Planning Commission Meeting July 6, 2020

**City of Fairhope
Planning Commission Agenda
5:00 PM
Council Chambers
July 6, 2020**

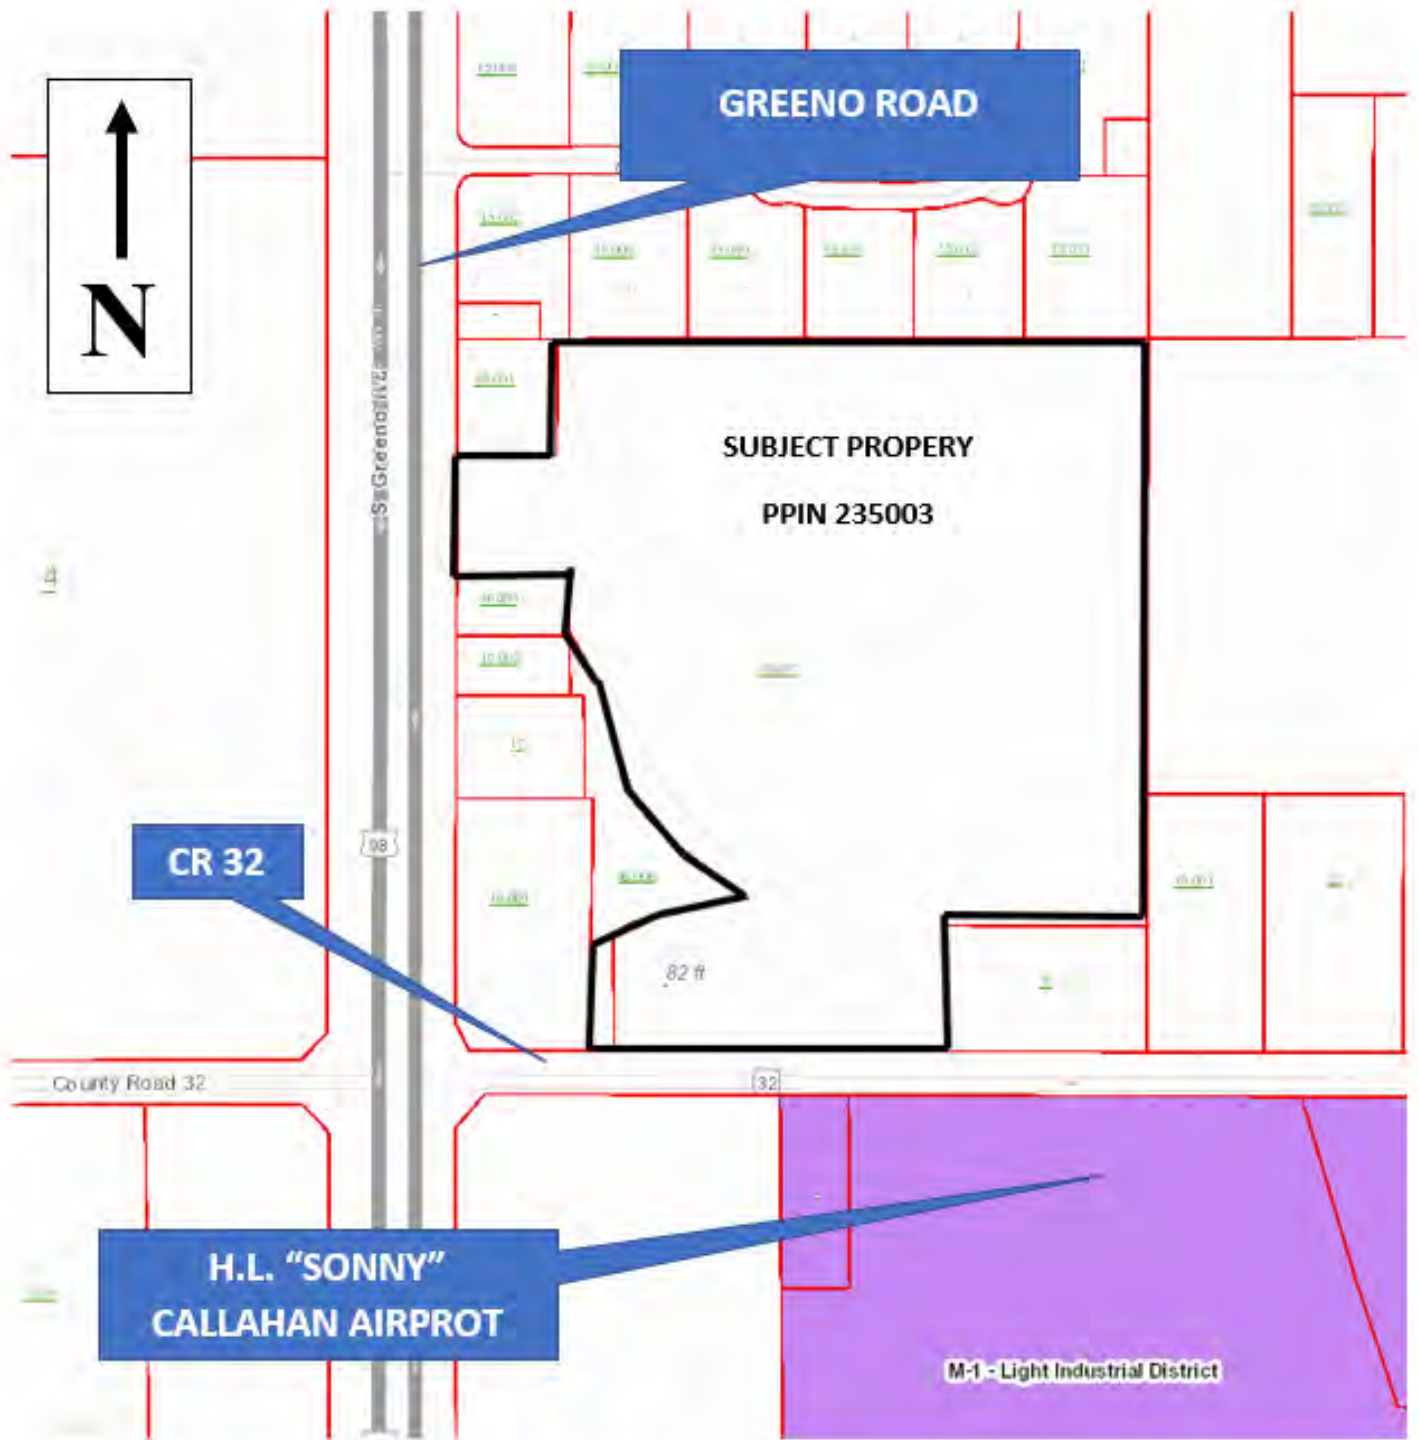
- b. The plat has been amended to reflect Lot 1 as a "flag" lot that fronts upon Greeno Road and thus meets the requirements of this section.
- *Article IV, Section C.1.c. Street Plan Requirements*

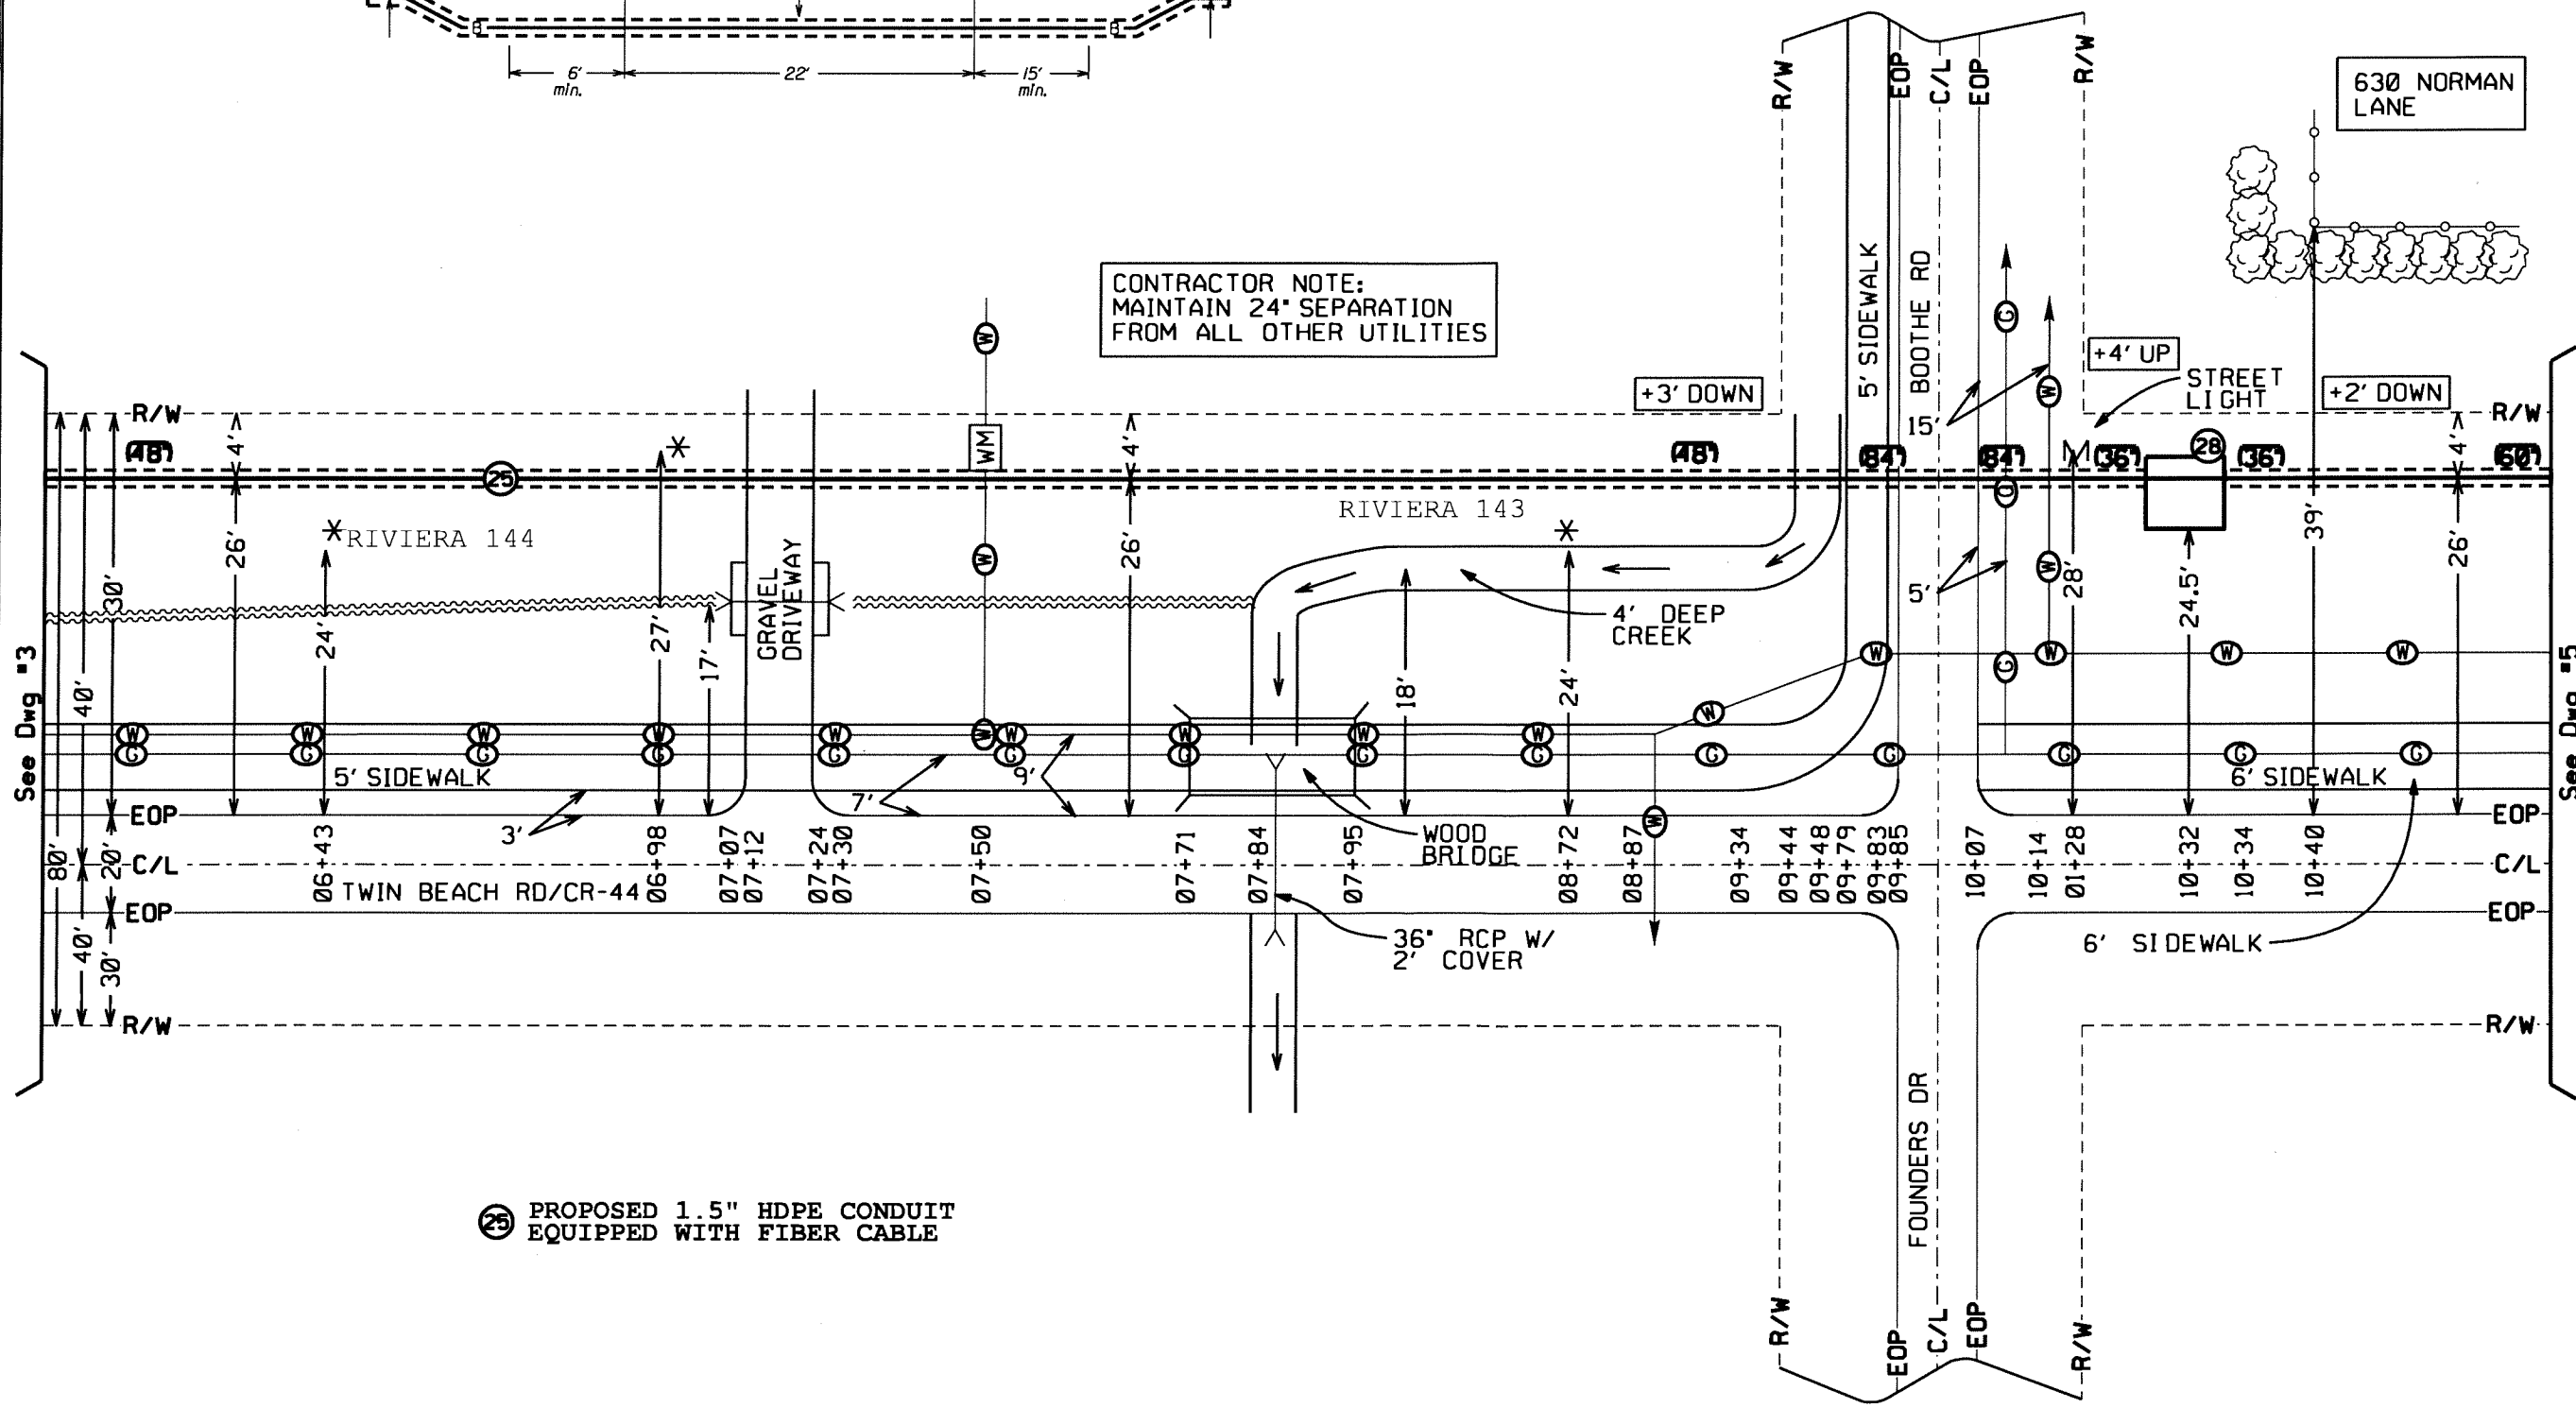
2. Edit the note on drawing 4 of 11 to reflect 36" separation from all drainage and utilities
3. At all street crossing locations, conduct potholing to determine exact location and elevation of existing utilities. Reflect the exact elevation of utilities and gps coordinates of the pothole locations on a set of as-built drawings.

CONTRACTOR NOTE:
MAINTAIN 24" SEPARATION
FROM ALL OTHER UTILITIES
